# **APPROVED MAJOR DEVELOPMENT PLAN MINOR VARIATION MULTI-STOREY OFFICE DEVELOPMENT**

**3 WELLINGTON PLACE, MAJURA PRECINCT CANBERRA  
AIRPORT**

Project Approved Final Minor Variation to Major Development Plan Multi-storey  
commercial office building  
Site 3 Wellington Place, Majura Park, Canberra Airport ACT  
Applicant Canberra Airport  
Date 28 November 2025  
Revision 05

Figure 2: 3 Wellington Place June 2025 Site Plan

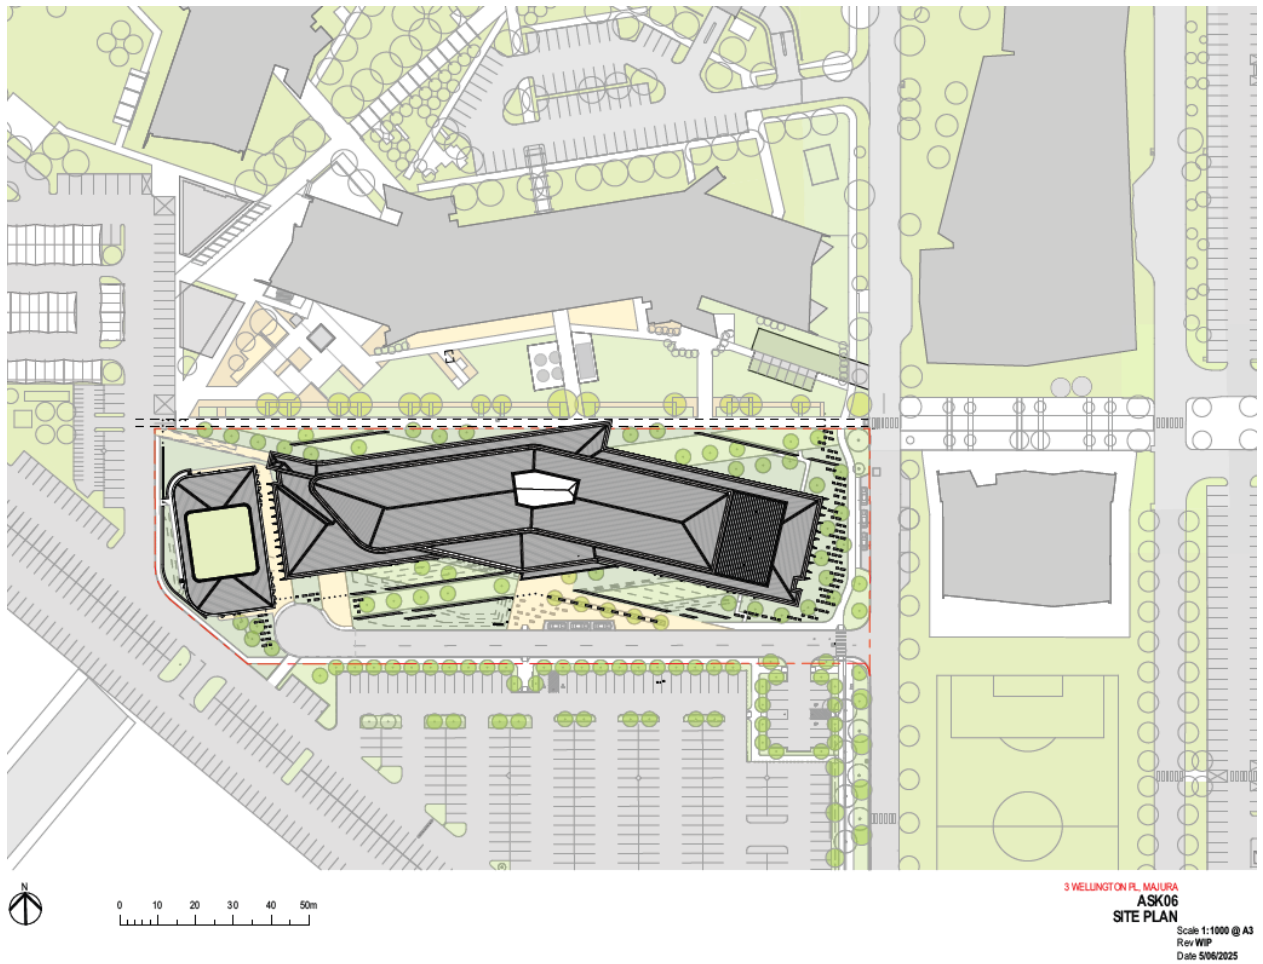
An update design for the 3 Wellington Place development dated June 2025 has been proposed (Figure 2 and Figure 3). The main building has increased in length by 24.3m (121.4m to 145.7m) and decreased in height by 1.8m (27.2m to 25.4m). The 3 Wellington Place development is located 25m south of the combined 1 Wellington Place / 5 Lancaster Place development. The 1 Wellington Place / 5 Lancaster Place development has a maximum height of 24.7m and overall length of 145m which is similar to the updated 3 Wellington Place design. The 25 Catalina Drive development is tallest of this group of buildings with a height of 27m.

It is expected that the updated 3 Wellington Place development will generate a similar small increase in the probability of exceeding the criteria as the original 3 Wellington Place design, as it maintains the approved development's location relative to the existing buildings and the runway as well as its comparable size with these existing buildings. Although, the specific locations in elevation and chainage of the increases in turbulence described in the original report may change.

Furthermore, the updated design will not change the conclusion that "The minor increases in turbulence along the 12/30 runway do not impact operational conditions for General Aviation aircraft less than 5.7 tonnes landing on runway 12". This is due to discussion above the limitations on landing on Runway 12/30 and the recommend maximum tail wind speeds for landing for these aircraft.
